Our Ref: 3063
Date: 6 December 2024
To Monteath & Powys
ATTN: Jamie Graham

RE: Further RFI to DA 16-2023-685-1 at 42 Fullerton Cove Road Fullerton Cove, NSW (Lot 14 DP2588480) as requested by Port Stephens Council / Hunter & Central Coast Regional Planning Panel

Summary of Ecological Assessment

Title: Figure 2 - Avoid (BMP Lands) and Minimise (Landscape Plan Native Species)
Location: 42 Fullerton Cove Road, Fullerton Cove NSW
Client: Monteath and Powys

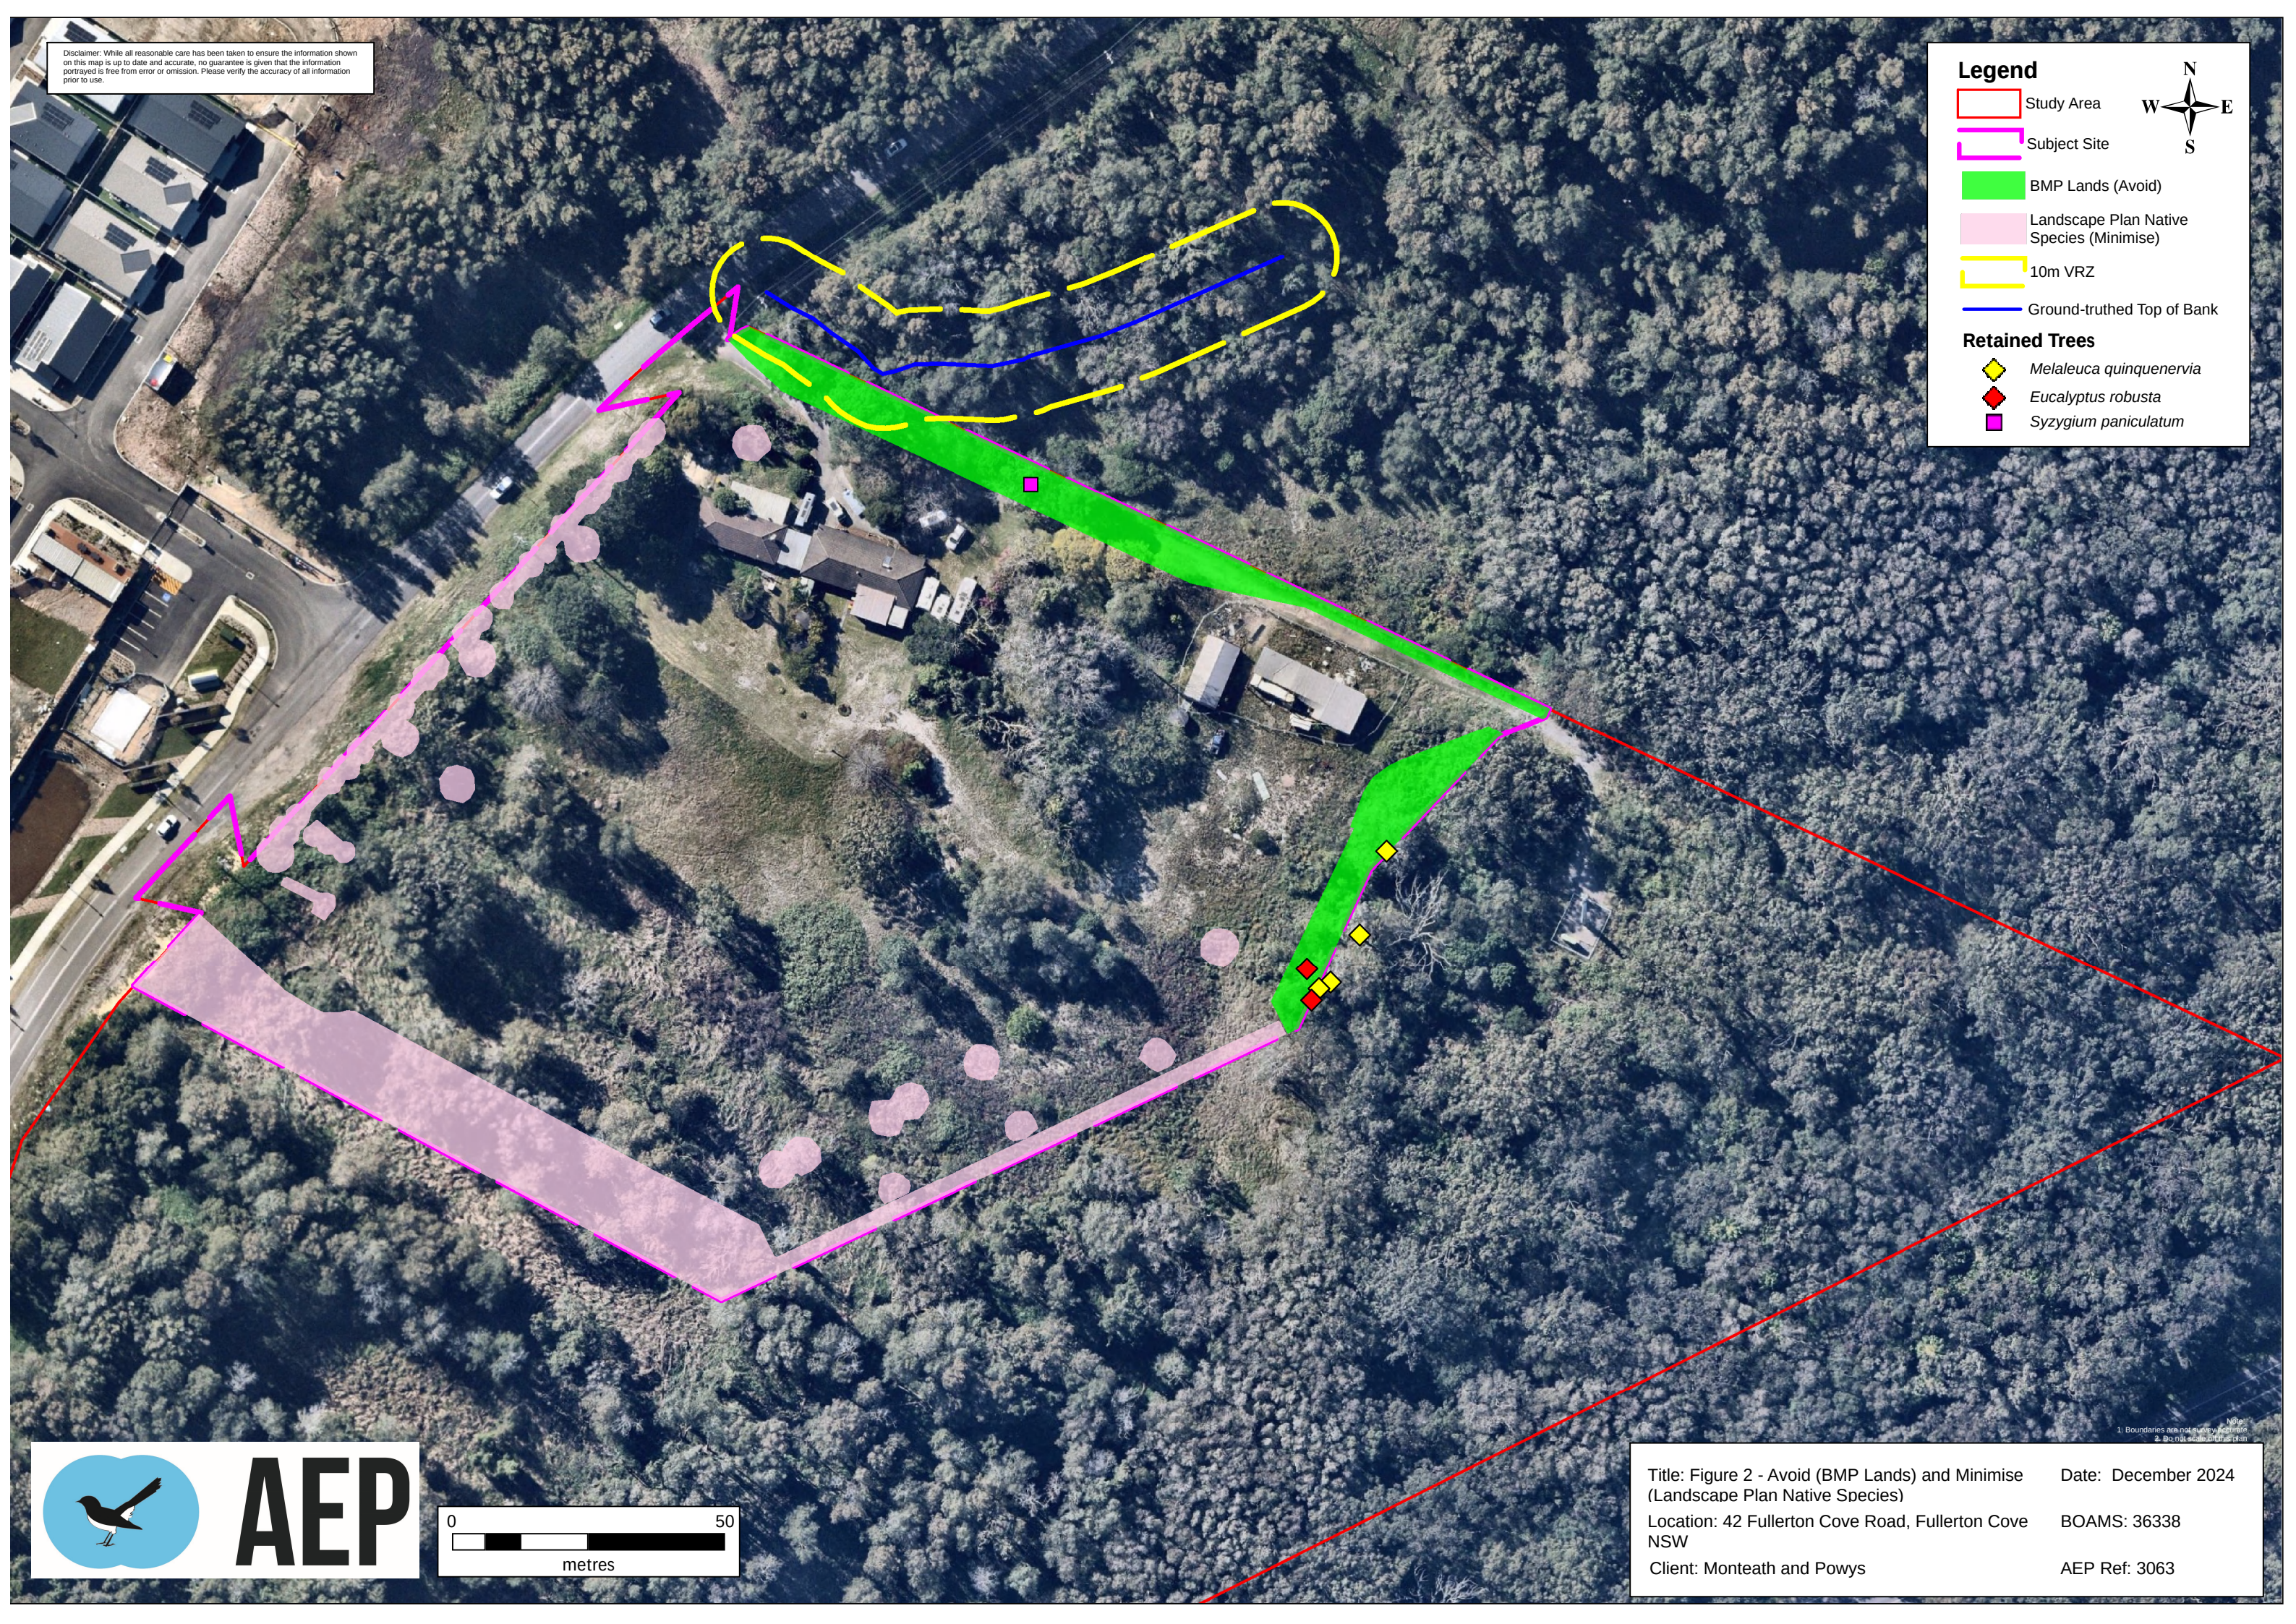
- *The biodiversity needs further consideration of just the E1 Local Centre zoned land and identify from Figure 4 of the BDAR the nature of vegetation, the areas avoided and how impacts have been minimised on the E1 Local Centre lands, and why this is appropriate in the context of the quality of vegetation.*

- *The Panel requests:*
 - *Analysis of the vegetation and ecology, specific to the E1 Local Centre zone lands and the avoidance and minimisation undertaken*

AVOID and MINIMISE within the E1 zoned land is as identified in **Figure 2**. Areas identified are shown with context to C2 lands due to location, connectivity and associated Plant Community Types (PCT’s), as indicated in **Figures 3 & 4**.

- Retention of Listed Koala Trees (**Figure 2**);
- Retention of listed species, and incorporation of weed removal to increase its health (**Figure 2**);
- Retention of vegetation along the watercourse (adjoining lands in the north) to provide an additional riparian vegetation, which as shown through many studies; increases water quality. This was an aim of the development to ensure there was an improvement to the water quality entering the Ramsar Wetlands located downstream of the adjoining watercourse (**Figure 2**).
- Provide additional foraging, roosting and nesting habitat for mobile fauna.
- Increase native seed banks within the local area and lower catchment.
